BELL SYSTEM PRACTICES
Station Installation
and Maintenance

ADDENDUM C66.507
Issue A, 9-23-43-C

541, 542 641 AND 642 TYPE
SUBSCRIBER SETS
CONNECTIONS

FIG. 7 USE OF KEY TELEPHONE UNITS IN LIEU OF 641-B OR 642-B SUBSCRIBER SETS

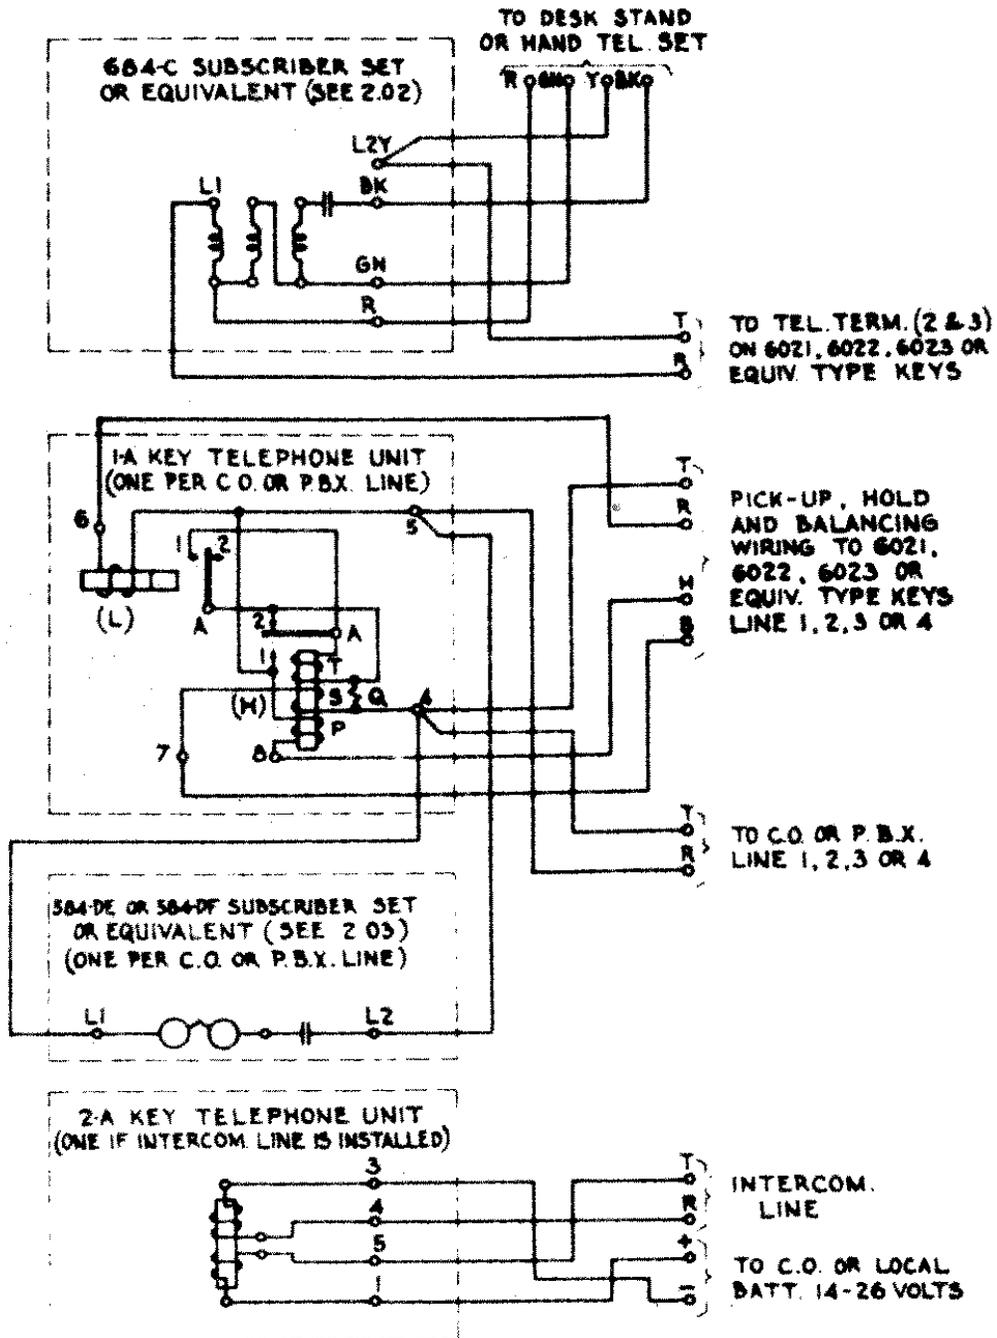
1.01 This addendum, which supplements Section C66.507, Issue 1, covers the use of key telephone units, in lieu of the 641B and 642B subscriber sets, to provide the holding and intercommunicating features of these sets in station wiring plans, when the 641B or 642B sets are not available.

2.01 The detailed wiring connections covering the use of the key units is covered in Fig.

7.

2.02 Subscriber sets for use as station ringers should be employed on central office or P.B.X. lines in accordance with requirements specified for line and ringer limitations for main and extension stations. (See Fig. 7.)
